T ECHNICAL INFORMATION

63604

Subject ▶ Change of Scirocco Fan

For Models ▶ DC14SA, DC24SA

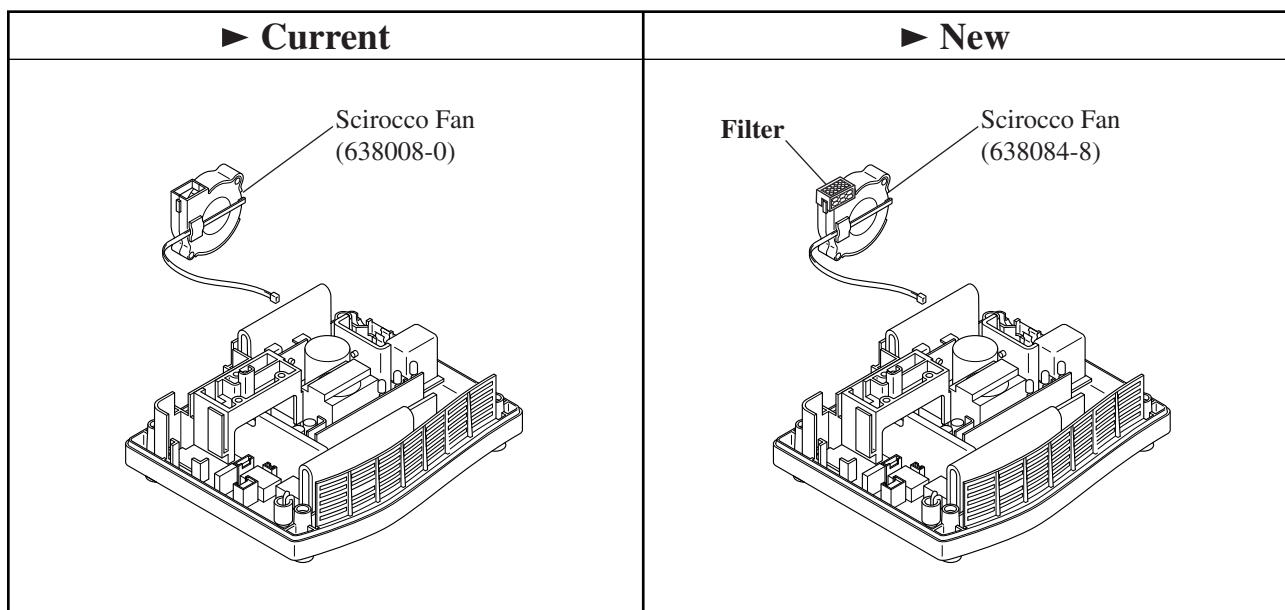
Description ▶ As illustrated below, an air filter has been added to the scirocco fan for further improvement in dust-proof construction.

Item No.	Current part		Q'ty	I/C	New part		Q'ty	Note
007	Scirocco Fan 638008-0		1	←	Scirocco Fan 638084-4		1
